The City of Spartanburg Design Review Board

AGENDA

February 6, 2024, at 6:00 P.M.

SUBJECT

South Elevation @ 1/8" = 1'-0"

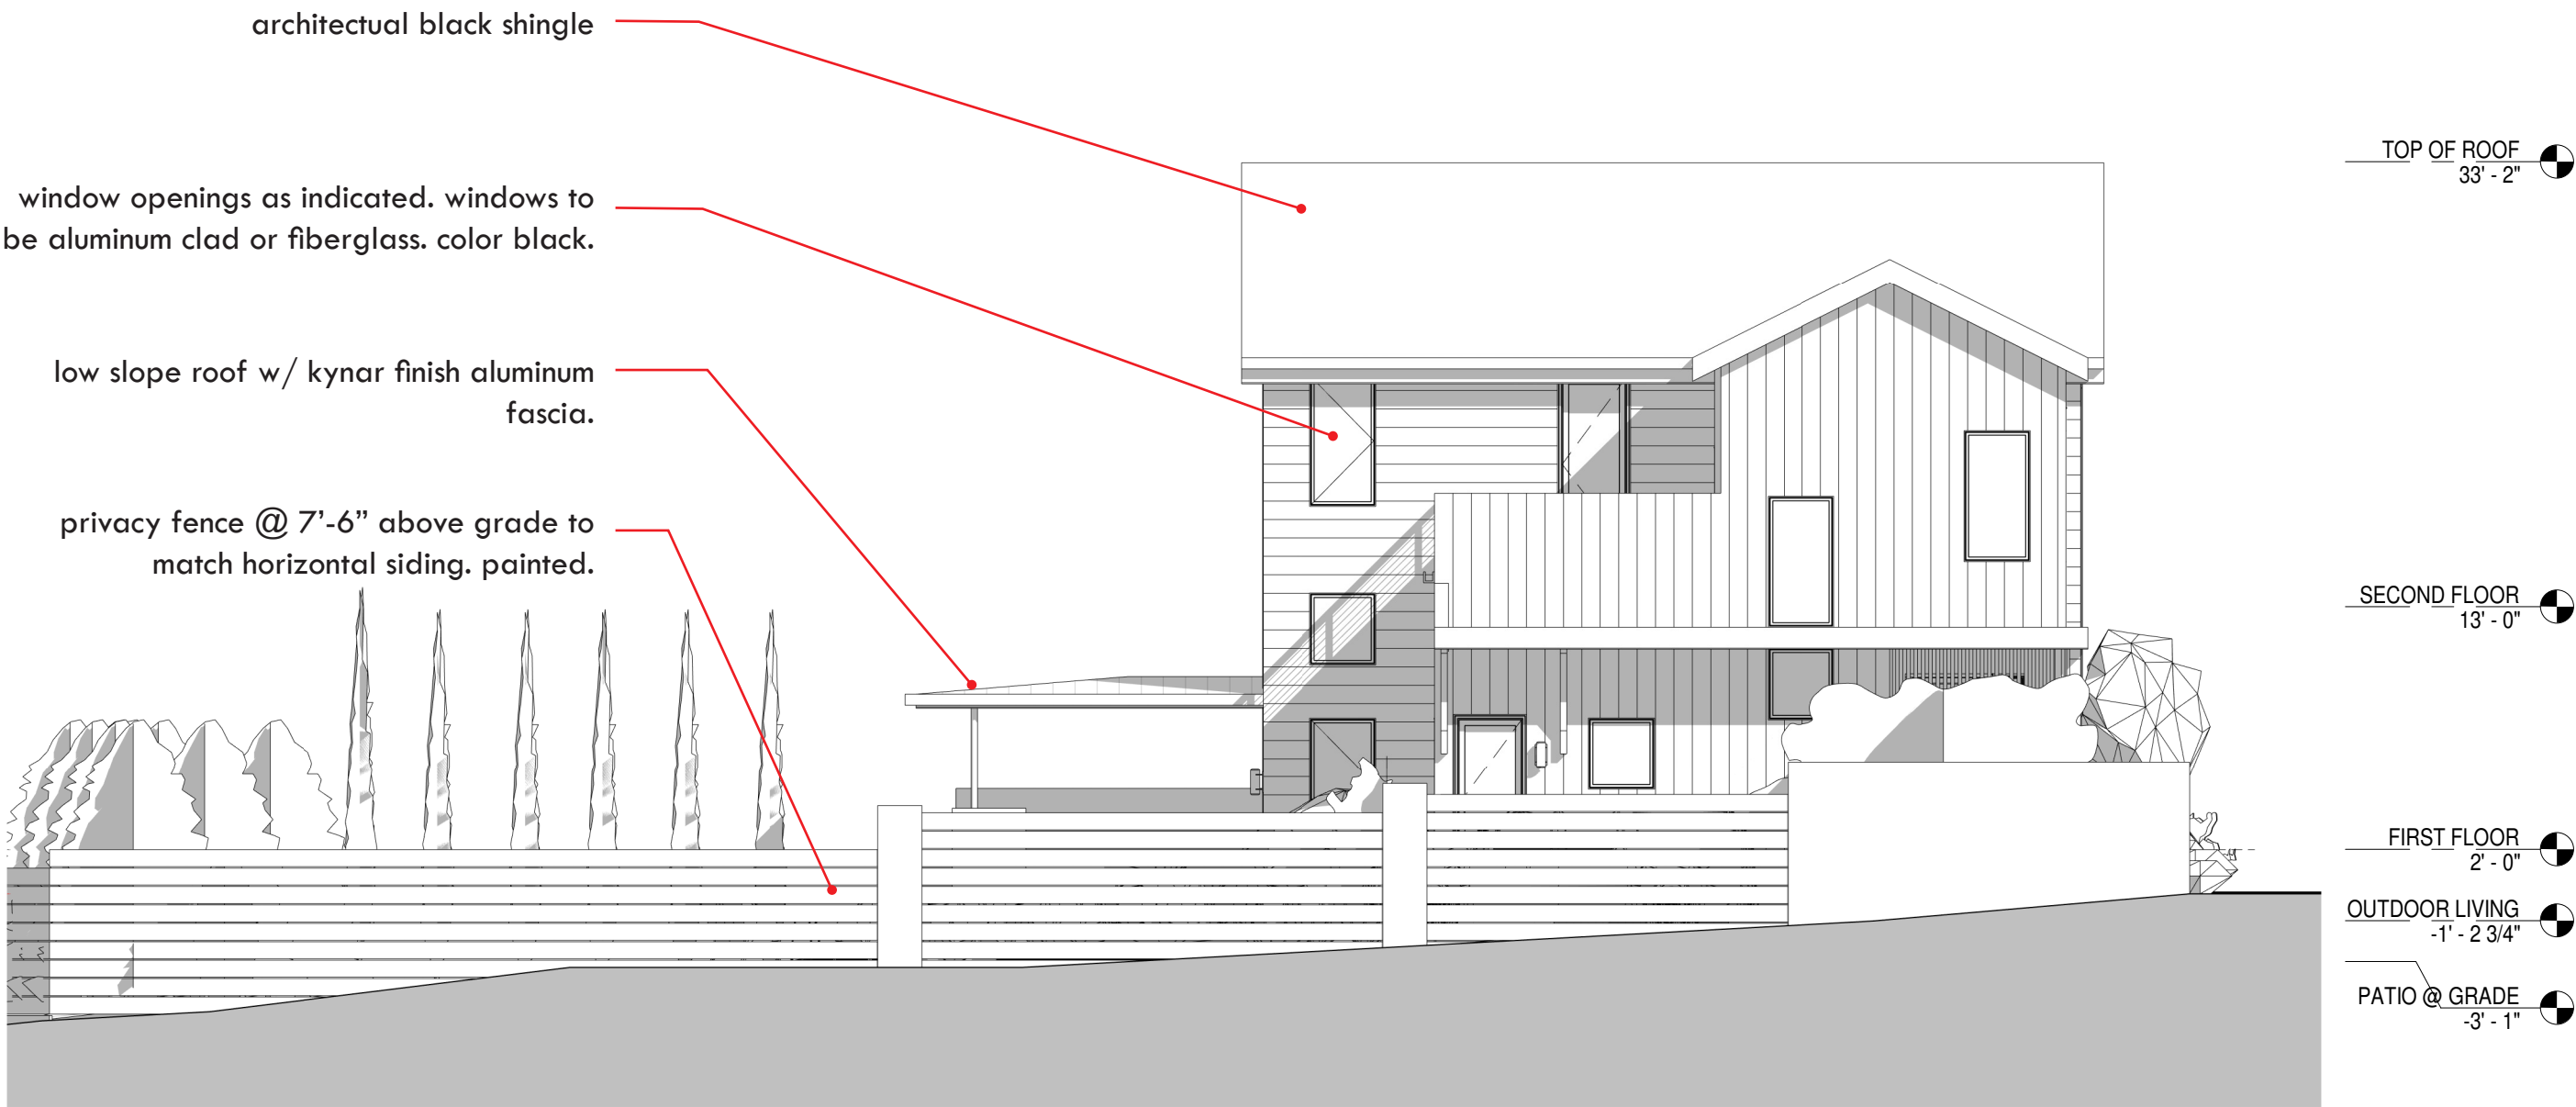
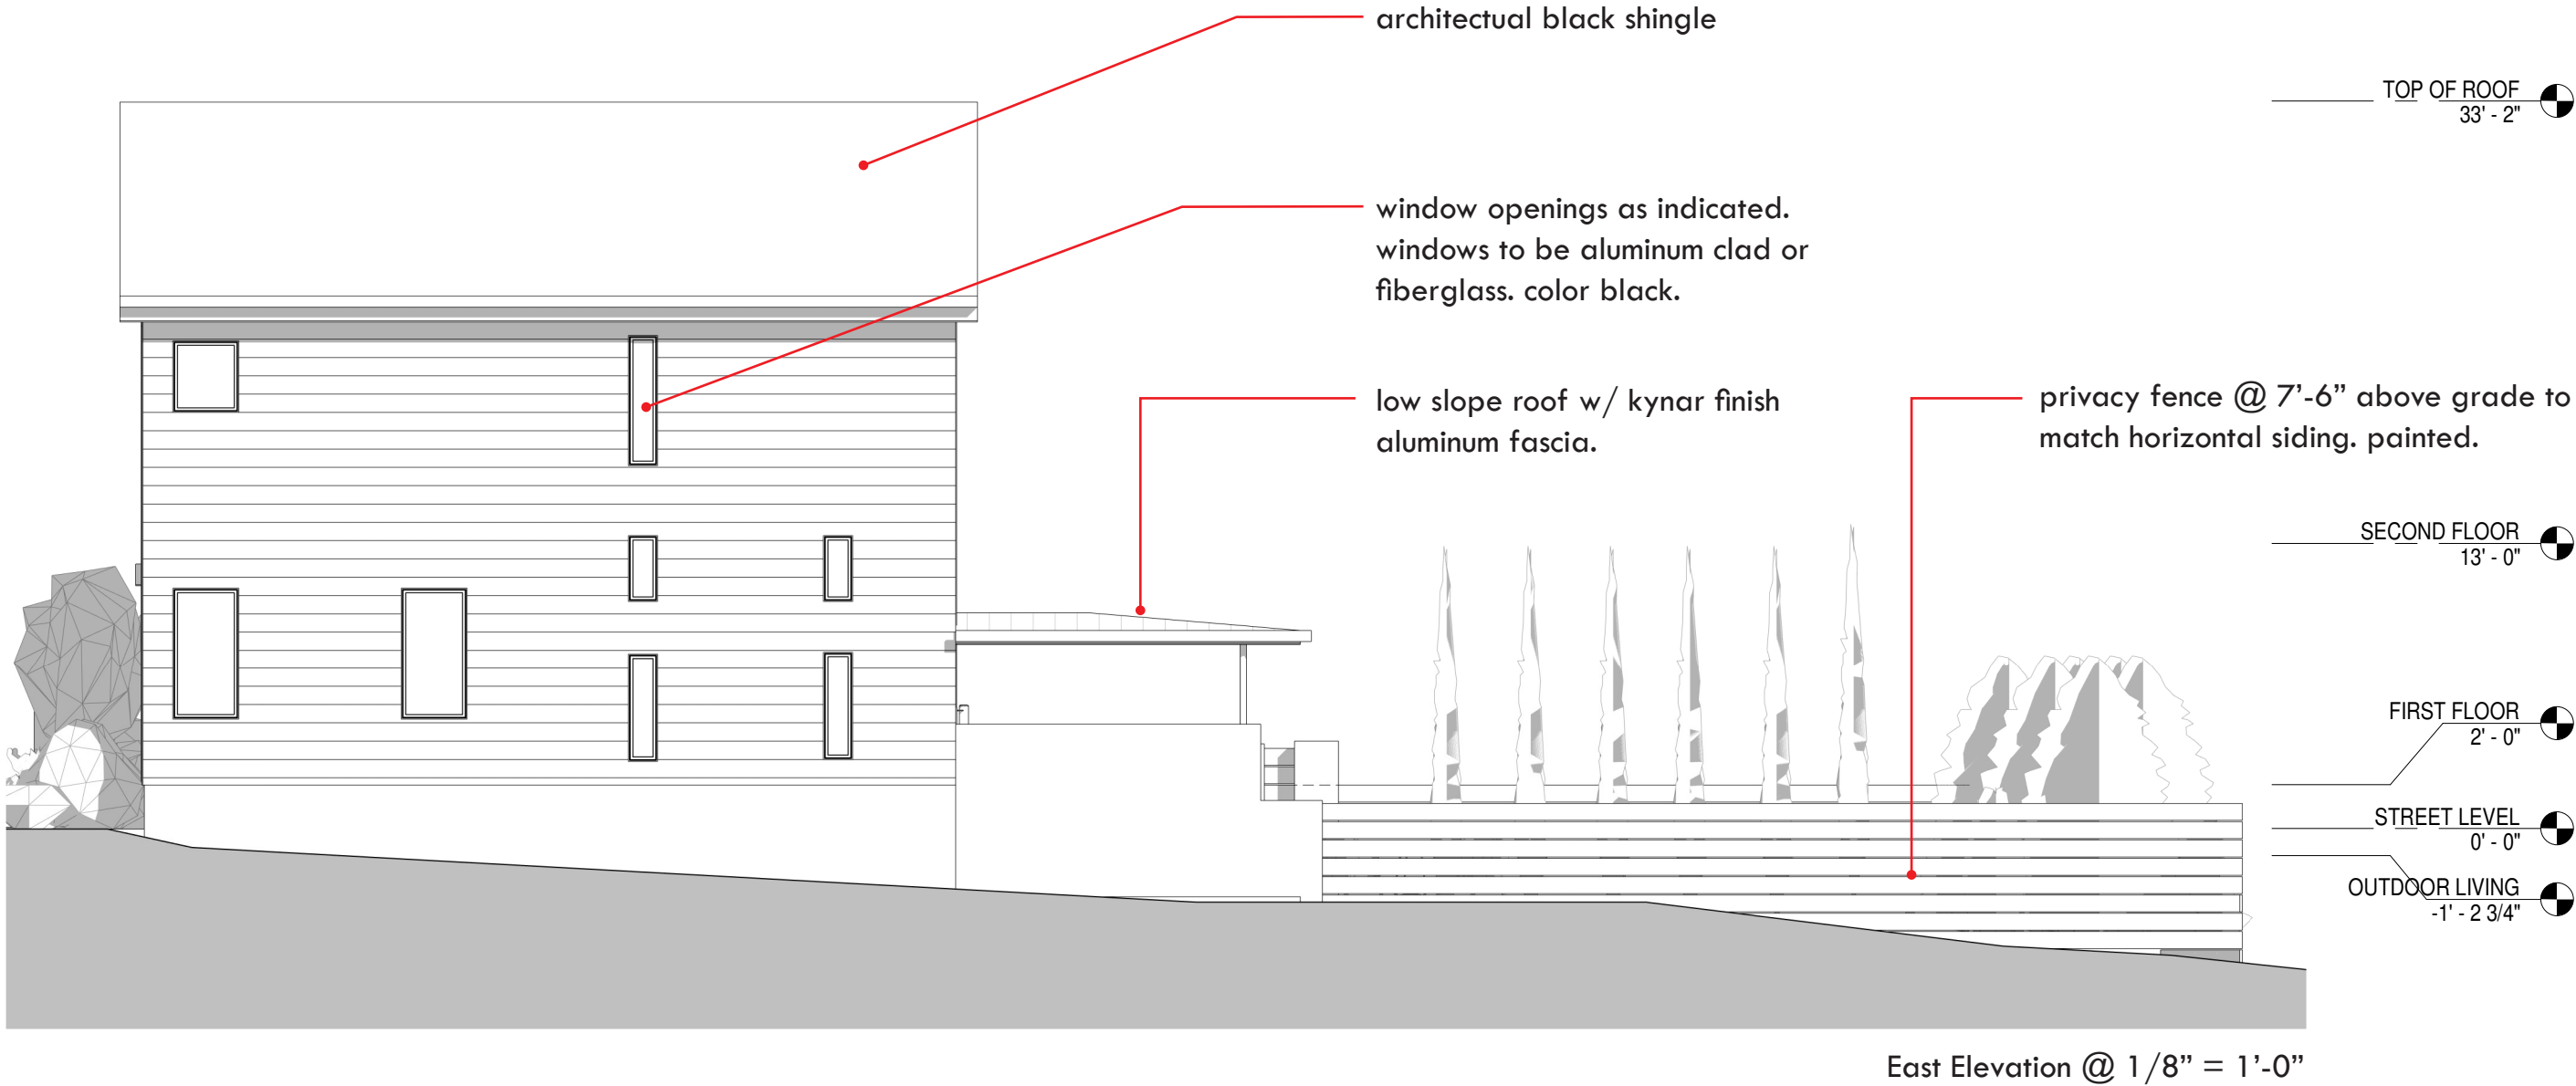
- **Color:** While the use of black as an exterior color is “on-trend”, it is not grounded in the vernacular of the region. Black can help to “pop” feature elements, but we think that the use of black as the predominant building color lacks visual interest. In this particular case, we would recommend that the window trim be thickened and painted with a light color (white or stained wood to match lower entry) and consider the use

of the lighter stained wood in the rake of the roof overhang. The same consideration could be made with the feature window on the gable-end front façade. We are also concerned with use of black on the board and batten walls and feature window inset panel. Black tends to be very unforgiving and large smooth panels tend to weather differently than lap siding, exposing weather damage sooner. As a south-facing home, this elevation will be exposed to weathering much more so than other elevations.

- **Wall Trim:** There is wall trim depicted on the front gable-end but not on any other elevation. Please confirm.

West Elevation @ 1/8'

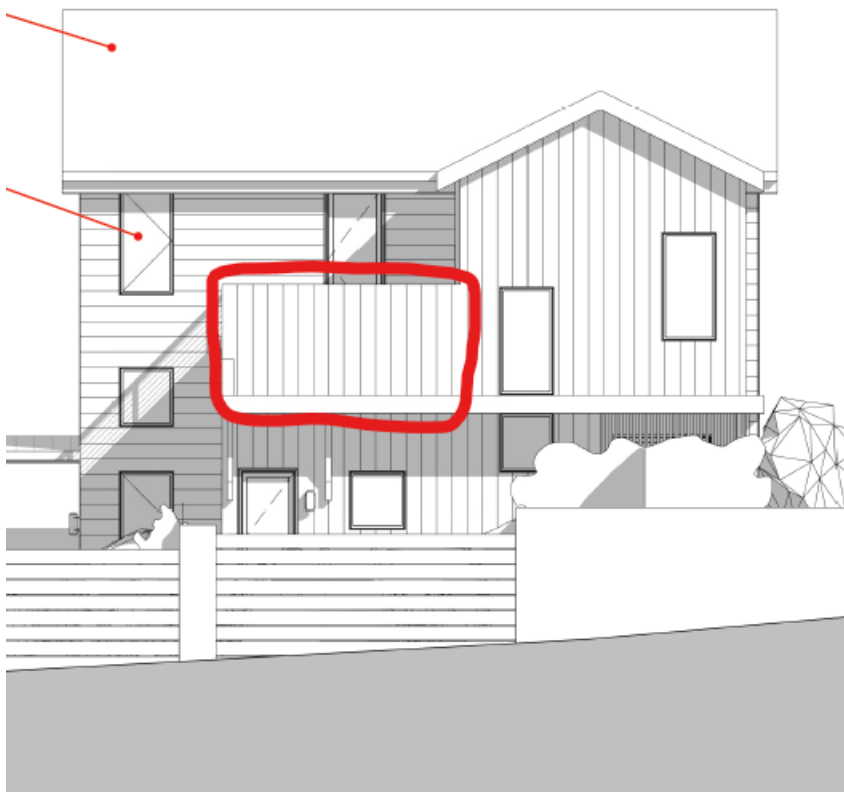
- **West elevation:** There appears to be an outdoor deck that is surrounded by an extension of the gable end wall using the board and batten treatment. First, it appears the window in this location should actually be a doorway based on the floor plan. And, as an outdoor space, we would recommend a stained cedar treatment similar to the entry area rather than extending the board and batten half wall to allow for air circulation on the patio. At a minimum, we recommend that an appropriate cap be placed on the top of the wall.

FRONT

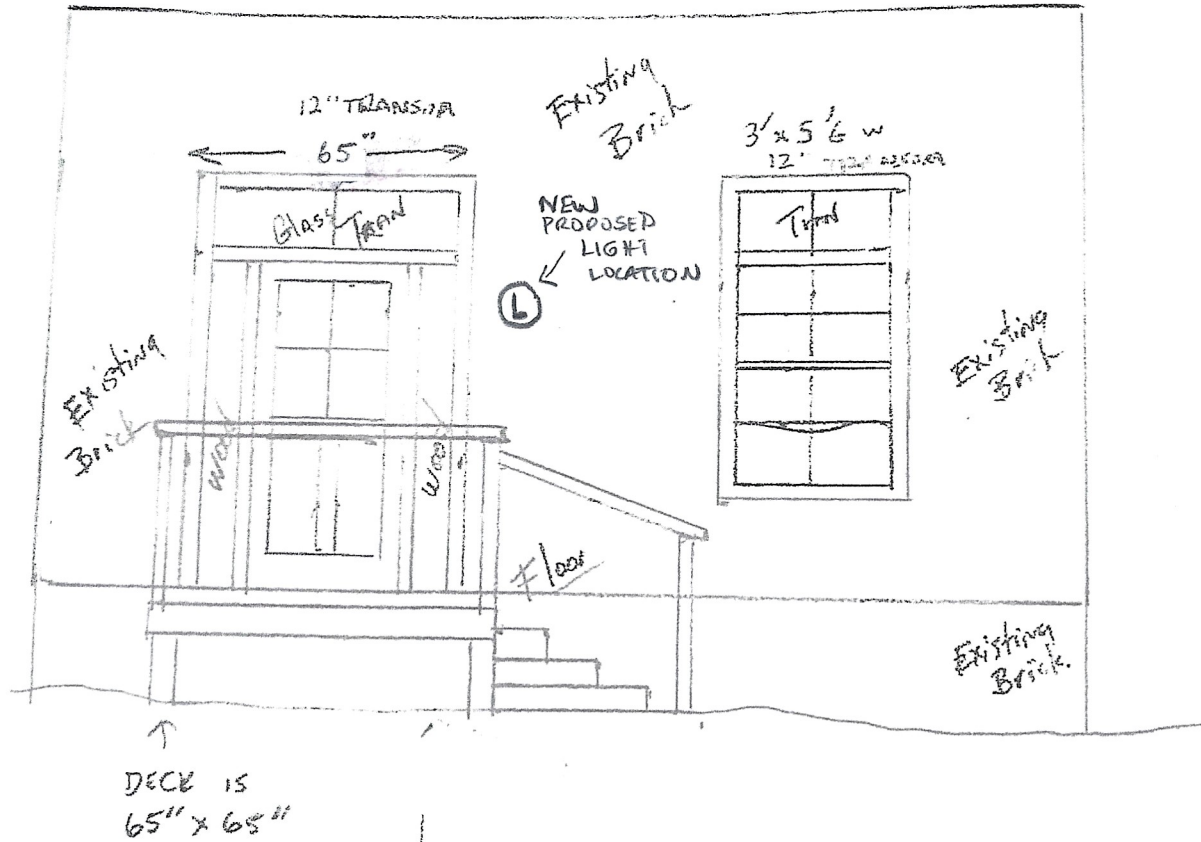
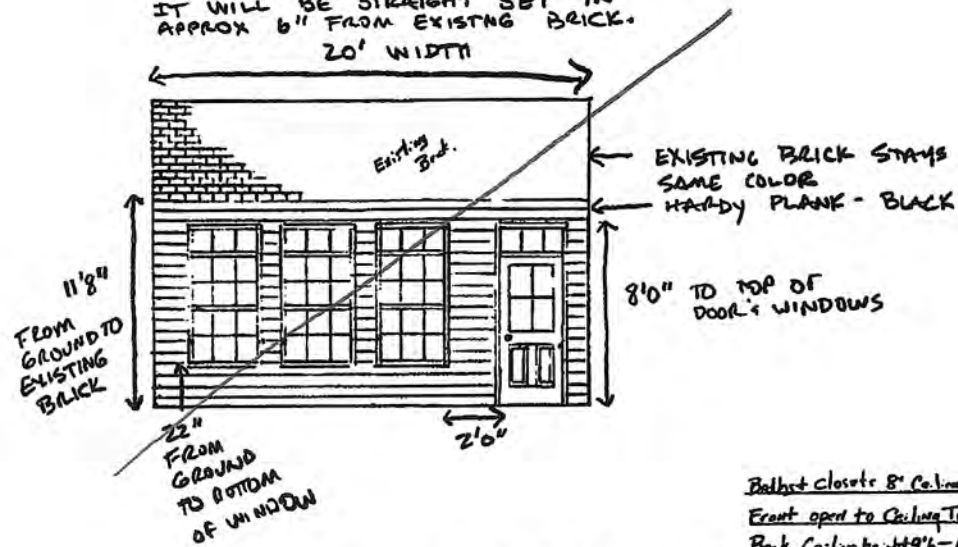
- **Front Unit Entry:** The proposed front façade is consistent with the neighboring commercial properties though we continue to question the direct access entry from the sidewalk into the living space of the unit. The code requires that residential units be elevated to provide a sense of privacy from the sidewalk but no alternate configuration has been provided. We would strongly encourage some type of visual offset or an entry vestibule to provide a more appropriate transition to the private space.

- **Front Façade Canopy/Awning:** The existing canopy is being removed and no replacement has been provided. It is appropriate to provide some type of covering over a doorway, at a minimum, to provide shelter from the elements before entry. Along Main Street, the canopies and awnings of buildings also provide shelter from sun and rain to pedestrians walking by. It appears that no canopies or awnings have been provided in the renovation of the facades of the neighboring buildings, however, that should not be the precedent. Because this application requires Board approval, we strongly recommend the installation of some type of a canopy or awning that is consistent with the other commercial storefronts along Main Street and with the code requirements.

- It appears that you are planning to recess the front façade 8" from the outer brick façade. Please confirm. Yes...one side (left) is already recessed at 8". We are making the right side match.

FRONT FACADE WILL NOT BE
 ANGLED AS IT CURRENTLY IS.
 IT WILL BE STRAIGHT SET IN
 APPROX 6" FROM EXISTING BRICK.
 20' WIDTH

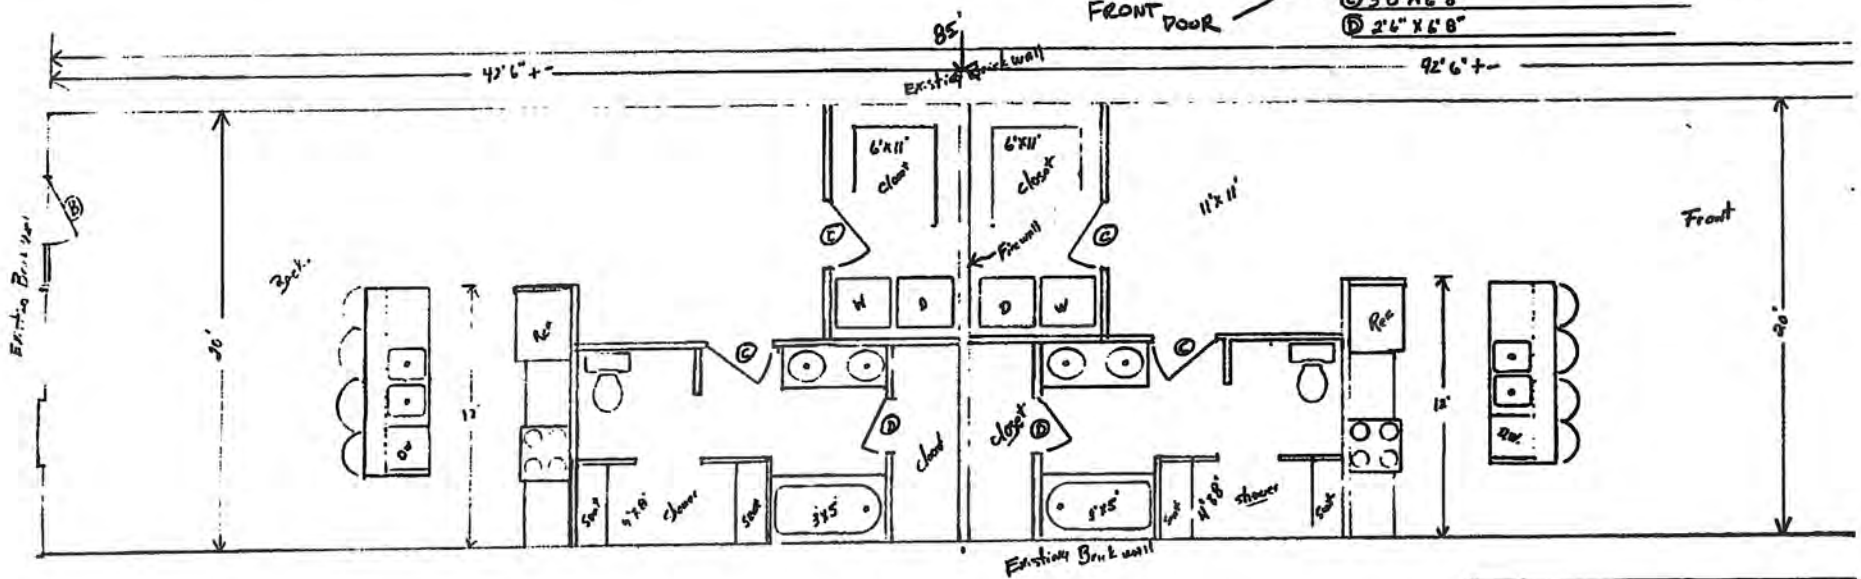
- The units as proposed appear to be open studios with no enclosed bedroom. The door appears to open in clear view of the bed location. We recommend altering the door location and providing a partial wall to provide some visual separation. Given that the street-side unit opens directly onto the public sidewalk, a visual screen is recommended. We have given this some consideration as well and like the idea of a temporary/moveable partial wall similar to what our neighbor next door uses in front of his windows. We have been looking and have yet to find exactly what we want but do plan to provide this to the tenant.

- The rear elevation is showing an entry stair that conflicts with an existing HVAC unit. Will the current unit be demolished? Also, will this stair hit a landing and connect to a sidewalk? The HVAC unit has already been removed and no plans to put one back there. There are no sidewalks at the rear, but we would be happy to provide a small concrete landing/patio area at the bottom of the steps.

- The units as currently proposed are quite deep and do not show opportunities for natural light from their entries, particularly in the bedroom. You had previously indicated the use of skylights or solar tubes? If so, please indicate on a roof plan. Our contractor advised against the use of sky lights based on roof slope and potential for leaks, however in the new design, has added very generous transoms over the windows and doors that will always be open (no blinds) and provide a good amount of natural light.
